**Site Inspection Report for Per- and Polyfluoroalkyl
Substances at SVAD-067 – Fire Training Area and
SVAD-084 – Scrap Wood Open Burn Area**

**Savanna Army Depot Activity
Savanna, Illinois**

Final

| <p>FIGURE: 2-2</p> | <p>DATE: 12/11/2018</p> |

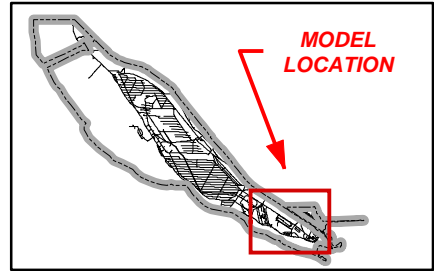
6. **Section 2.6.1, Geology/Hydrogeology at SVAD-067, Page 2-5; Figure 2-2, Lower Post Area Groundwater Elevation Normal Flow Conditions – July 1999, Page 2-6; Figure 2-3, Lower Post Area Groundwater Elevation Reversed Flow Conditions – June 2000, Page 2-7; and, Section 2.6.2, Geology/Hydrogeology at SVAD-084, Page 2-8:** The groundwater flow maps referenced in Sections 2.6.1 and 2.6.2 may not be representative of current groundwater flow conditions. Figures 2-2 and 2-3 indicate that July 1999 and June 2000 groundwater elevation data were used to determine groundwater flow directions, respectively. However, Worksheet #13a (Secondary Data Uses and Limitations) of the Final Addendum 2 Uniform Federal Policy Quality Assurance Project Plan, Site Inspection at SVAD-067 and SVAD-084, dated August 2018 (the Final UFP-QAPP) indicates that information in the Final Remedial Investigation Report for the Lower Post, dated October 2004 (the 2004 Lower Post RI Report) and the Remedial Investigation Report for Sites 46, 76CS, 84, and 184, dated December 2007 (the 2007 RI Report) were to be used to determine geology, hydrogeology, and groundwater flow directions. Revise the SI to address this discrepancy.

6. **Section 2.6.1, Geology/Hydrogeology at SVAD-067, Page 2-5; Figure 2-2, Lower Post Area Groundwater Elevation Normal Flow Conditions – July 1999, Page 2-6; Figure 2-3, Lower Post Area Groundwater Elevation Reversed Flow Conditions – June 2000, Page 2-7; and, Section 2.6.2, Geology/Hydrogeology at SVAD-084, Page 2-8:** The groundwater flow maps referenced in Sections 2.6.1 and 2.6.2 may not be representative of current groundwater flow conditions. Figures 2-2 and 2-3 indicate that July 1999 and June 2000 groundwater elevation data were used to determine groundwater flow directions, respectively. However, Worksheet #13a (Secondary Data Uses and Limitations) of the Final Addendum 2 Uniform Federal Policy Quality Assurance Project Plan, Site Inspection at SVAD-067 and SVAD-084, dated August 2018 (the Final UFP-QAPP) indicates that information in the Final Remedial Investigation Report for the Lower Post, dated October 2004 (the 2004 Lower Post RI Report) and the Remedial Investigation Report for Sites 46, 76CS, 84, and 184, dated December 2007 (the 2007 RI Report) were to be used to determine geology, hydrogeology, and groundwater flow directions. Revise the SI to address this discrepancy.

| FIGURE: 5-1 | DATE: 11/11/2020 |

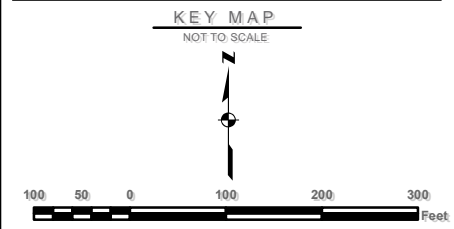
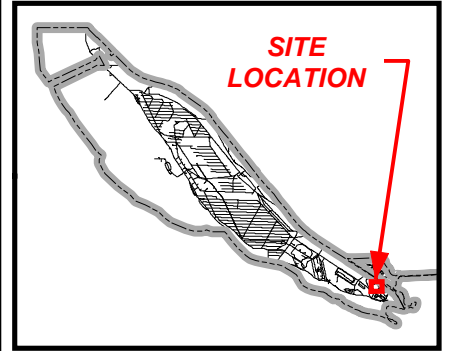
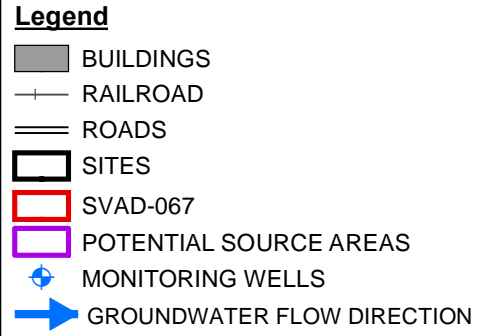
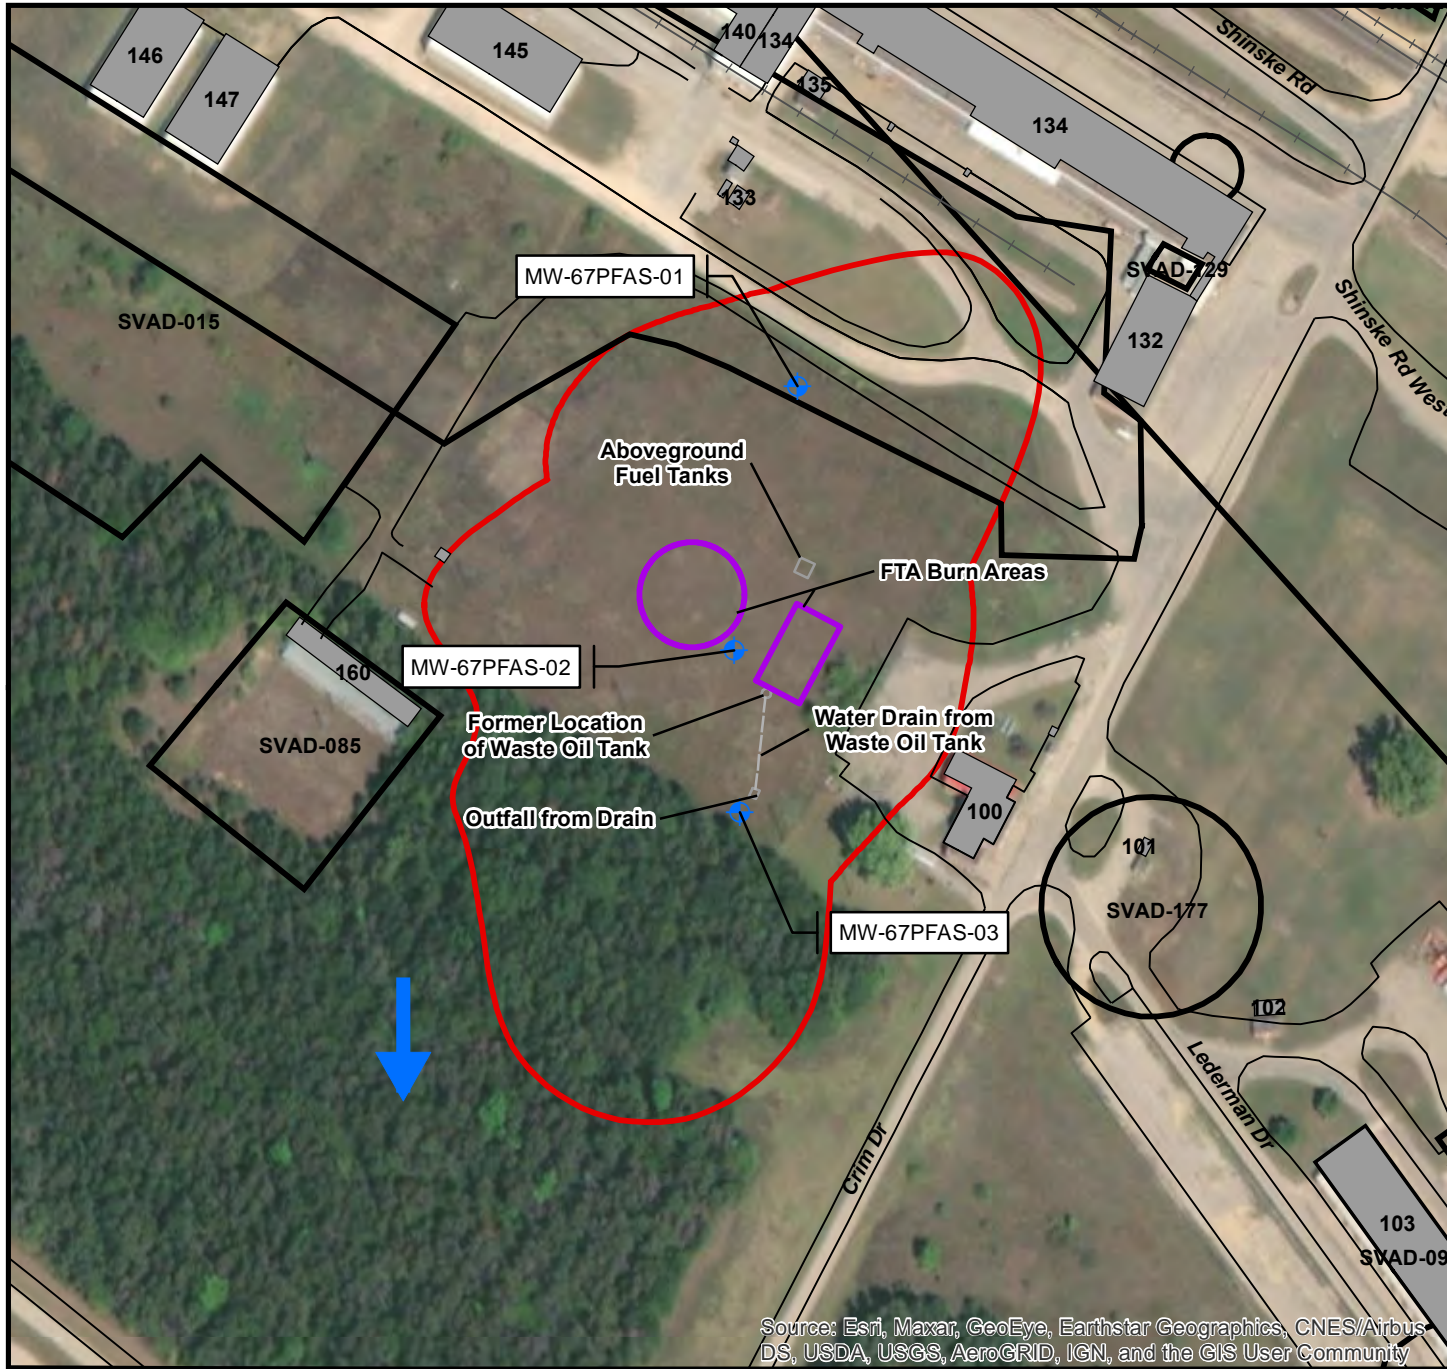
7. **Section 3.1, Field Investigation Activities, Page 3-1; Figure 5-1, SVAD-067 Fire Training Area, Page 5-2; and, Figure 6-1, SVAD-084 Scrap Wood Open Burn Area, Page 6-2:** The location description of the groundwater monitoring wells installed, and groundwater samples collected is inconsistent with the Figure depiction. The text in this section states that the groundwater samples were collected at and downgradient from SVAD-067 and SVAD-084. However, Figures 5-1 and 6-1 show the groundwater monitoring well locations as being within each site. Revise the SI to state that the groundwater samples were collected from groundwater monitoring wells located within SVAD-067 and SVAD-084.

14. **Figure 5-1, SVAD-067 Fire Training Area, Page 5-2; Figure 5-2, SVAD-067 Fire Training Area Analytical Results, Page 5-4; Figure 6-1, SVAD-084 Scrap Wood Open Burn Area, Page 6-2; and, Figure 6-2, SVAD-084, Scrap Wood Open Burn Area Analytical Results, Page 6-3:** The SI site-specific figures for each of the sites assessed do not display the location of all relevant current and historical site features discussed in Sections 5.1 (Site History) and 6.1 (Site History) (e.g., outfall areas, storage tanks, etc.). Revise the site-specific figures to include relevant site features for sites SVAD-067 and SVAD-084.

7. **Section 3.1, Field Investigation Activities, Page 3-1; Figure 5-1, SVAD-067 Fire Training Area, Page 5-2; and, Figure 6-1, SVAD-084 Scrap Wood Open Burn Area, Page 6-2:** The location description of the groundwater monitoring wells installed, and groundwater samples collected is inconsistent with the Figure depiction. The text in this section states that the groundwater samples were collected at and downgradient from SVAD-067 and SVAD-084. However, Figures 5-1 and 6-1 show the groundwater monitoring well locations as being within each site. Revise the SI to state that the groundwater samples were collected from groundwater monitoring wells located within SVAD-067 and SVAD-084.

14. Figure 5-1, SVAD-067 Fire Training Area, Page 5-2; Figure 5-2, SVAD-067 Fire Training Area Analytical Results, Page 5-4; Figure 6-1, SVAD-084 Scrap Wood Open Burn Area, Page 6-2; and, Figure 6-2, SVAD-084, Scrap Wood Open Burn Area Analytical Results, Page 6-3: The SI site-specific figures for each of the sites assessed do not display the location of all relevant current and historical site features discussed in Sections 5.1 (Site History) and 6.1 (Site History) (e.g., outfall areas, storage tanks, etc.). Revise the site-specific figures to include relevant site features for sites SVAD-067 and SVAD-084.

| FIGURE: 6-1 | DATE: 11/11/2020 |

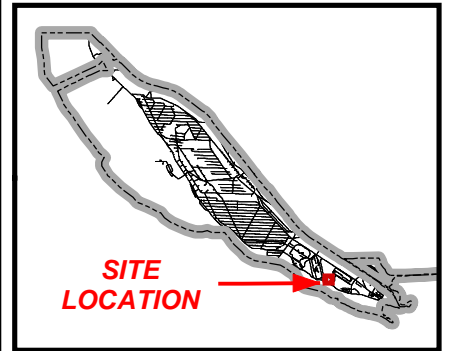
15. **Section 6.1, Site History, Page 6-1; Figure 6-1, SVAD-084 Scrap Wood Open Burn Area, Page 6-2; and, Figure 6-2, SVAD-084, Scrap Wood Open Burn Area Analytical Results, Page 6-3:** Based on Figures 6-1 and 6-2, MW-84PFAS-02 was advanced in the “IRA Actual Remediation Area”; however, it is unclear how advancement of a monitoring well within a previously excavated area is appropriate to investigate site conditions and a source area. This is of note given that Section 6.1 indicates that “approximately 3,232 tons of nonhazardous soil and debris were excavated and disposed of offsite.” As such, the analytical results from MW-84PFAS-02 may be under-representing the site conditions and the source area. Revise the SI to clarify how advancement of a monitoring well within a previously excavated area is appropriate to investigate site conditions and a source area.

15. Section 6.1, Site History, Page 6-1; Figure 6-1, SVAD-084 Scrap Wood Open Burn Area, Page 6-2; and, Figure 6-2, SVAD-084, Scrap Wood Open Burn Area Analytical Results, Page 6-3: Based on Figures 6-1 and 6-2, MW-84PFAS-02 was advanced in the “IRA Actual Remediation Area”; however, it is unclear how advancement of a monitoring well within a previously excavated area is appropriate to investigate site conditions and a source area. This is of note given that Section 6.1 indicates that “approximately 3,232 tons of nonhazardous soil and debris were excavated and disposed of offsite.” As such, the analytical results from MW-84PFAS-02 may be under-representing the site conditions and the source area. Revise the SI to clarify how advancement of a monitoring well within a previously excavated area is appropriate to investigate site conditions and a source area.
